D E S I G N
R E V I E W
C O M M I T T E E
S T A F F R E P O R T

2213 Fourth Street

PRELIMINARY DESIGN REVIEW

Design Review #DRCP2021-0005 to demolish three existing non-residential buildings and one existing duplex and construct a new 128,143 square-foot, five-story parking garage containing 415 off-street automobile parking spaces and one loading space to serve uses in the vicinity of the project site.

LANDSCAPE PLAN L1

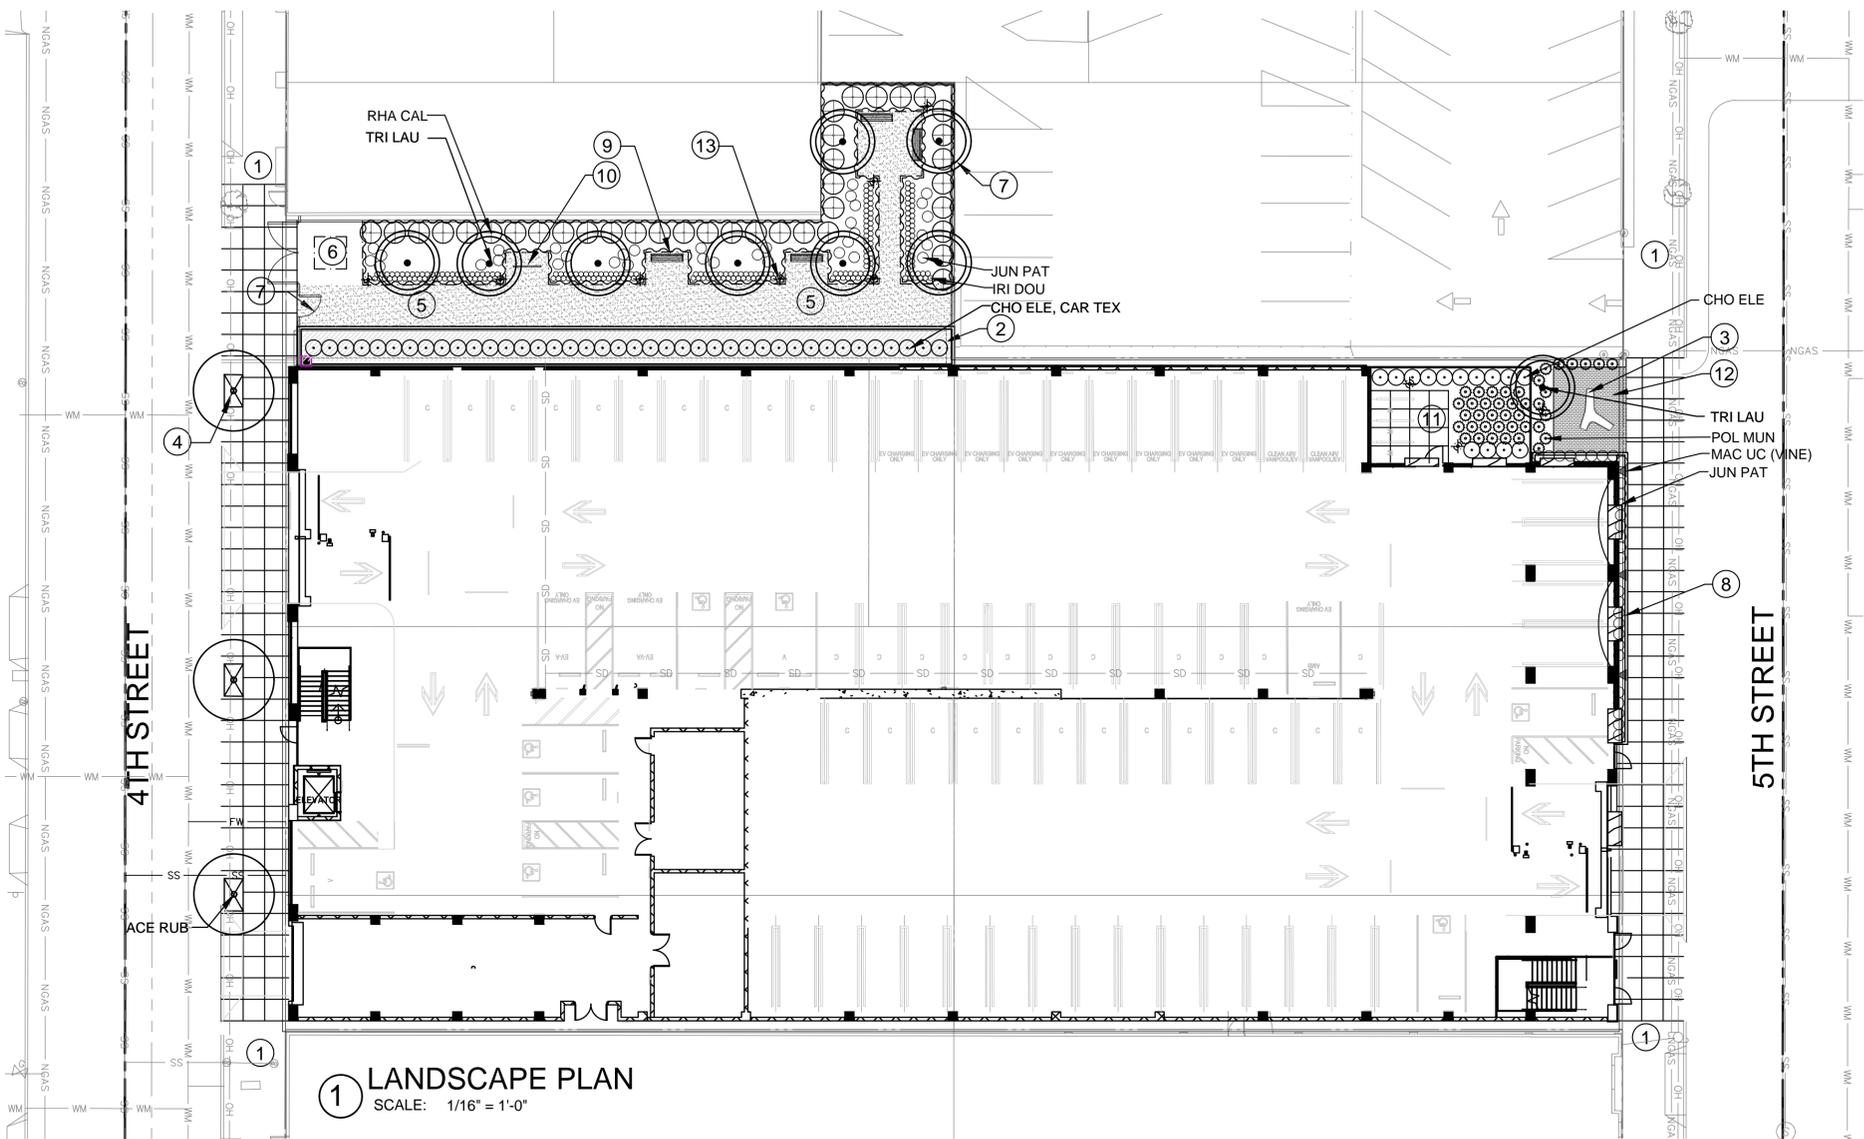
7	Consider a Fifth Sree structure in the Northwest corner of the site has could be accessed by the public.	L1, A103, A119	Project provide a structure at the NW corner of the site. It is designed to be open to the public with benches and landscaping.
Building Design			
8	Recommend pulling the solar panel away from the Fifth Sree edge of the structure, as well as away from the Northwest corner in the mapping.	A107.1, A108, A109, A119	PV structure has been pulled away from the Sree edge by two parking column bay to improve the sight line from the street .
9	Recommend pulling the second floor back on the Fifth Sree side.	A115, A116, A118, A119	See the response to first comment in the Neighborhood Context .
10	Use the form of the Center Sree garage to find a more unique structure for his neighborhood.	A114, A119	Facade features on the Sree has been changed in ornamental metal panel with unique and architectural features , which provide interesting elements to the neighborhood.

BUILDING ELEVATIONS | A109

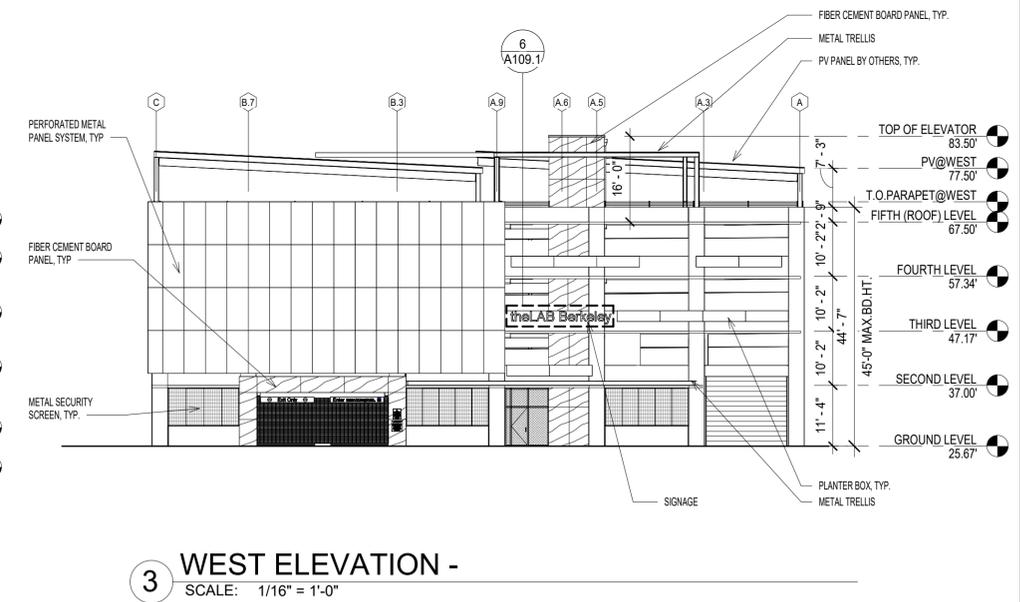
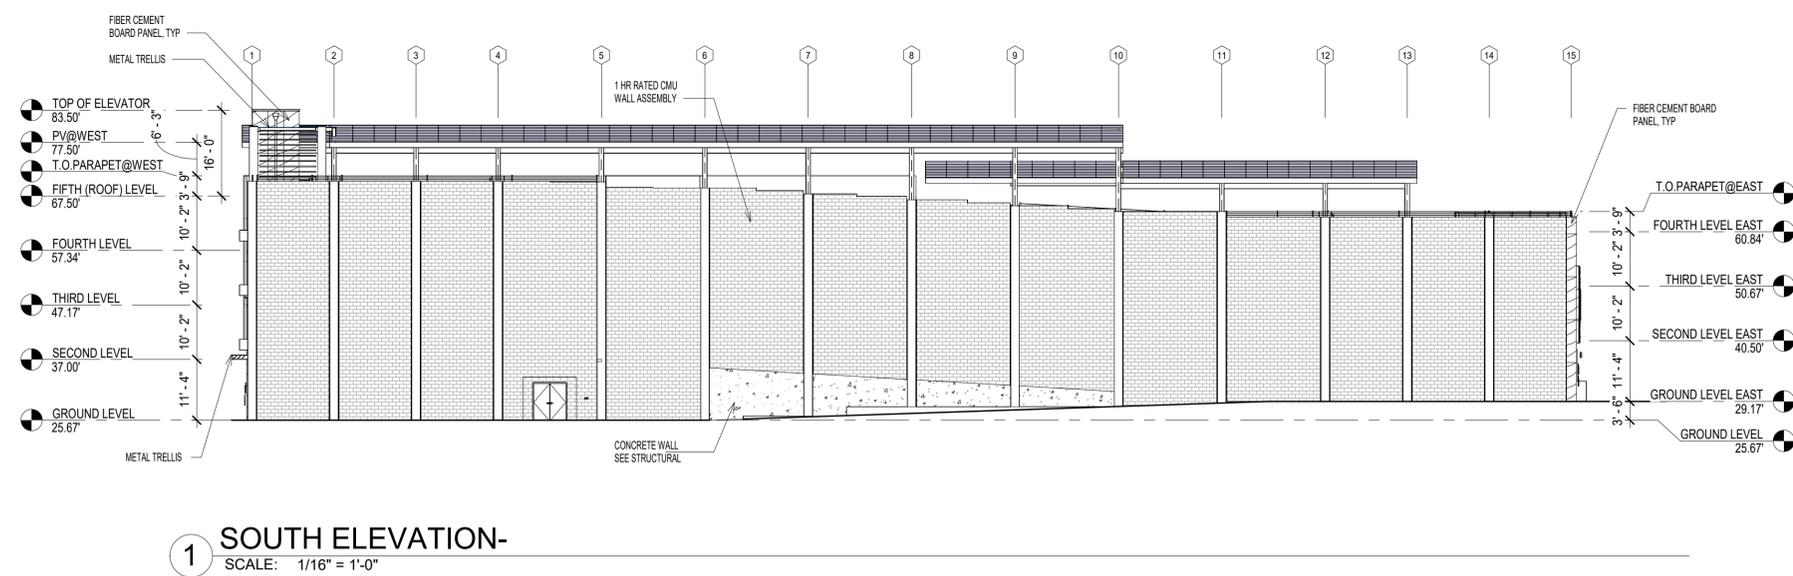
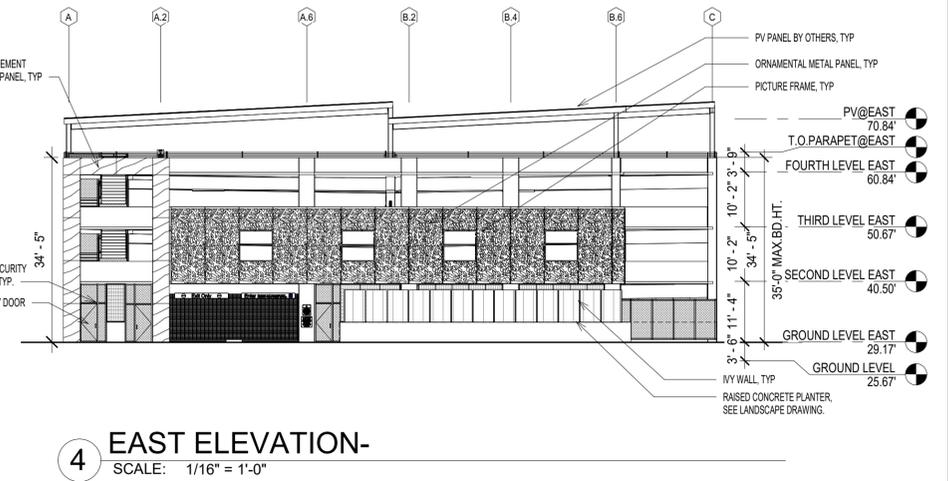
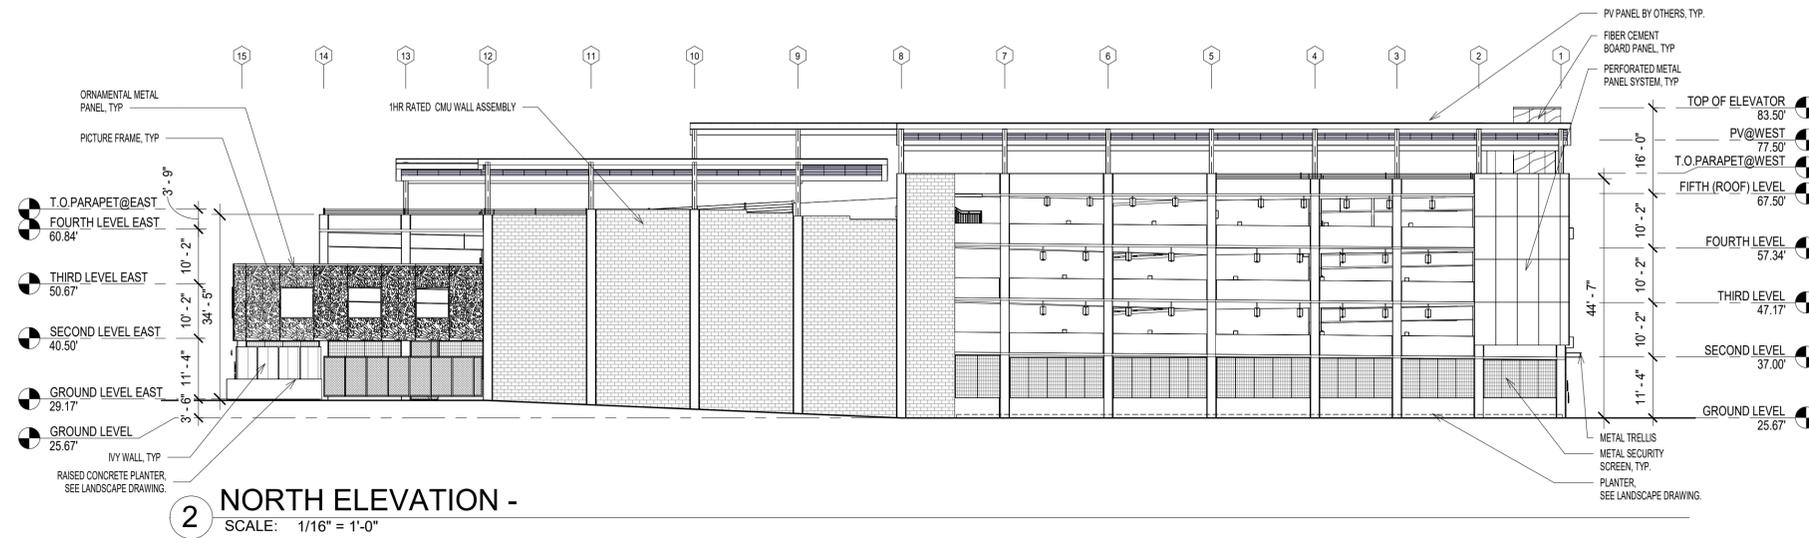
5	Design look too much like a parking garage (solid horizontal band and column); give more back to the neighborhood; consider more friendly elevation features .	A114, A119	See the response above.
6	Recommend relocating his project adjacent to the railroad track and away from his fixed-use Residential neighborhood.	NA	Relocating the parking garage to the surface parking lot adjacent to the new 747 Bancroft building would not be feasible due to fire access and building/life/safety issues that were raised during the project's staff roundtable meeting. Fire must have proper access to the new 747 Bancroft building as well as proper building separation which would be problematic with a parking garage located next to the 747 Bancroft building. Relocating the parking garage would also be detrimental to the overall design of the project and would negatively impact the design aesthetic of the 747 Bancroft building, including the proposed Ohlone medicinal herb garden which is incorporated into the design of the new 747 Bancroft building.
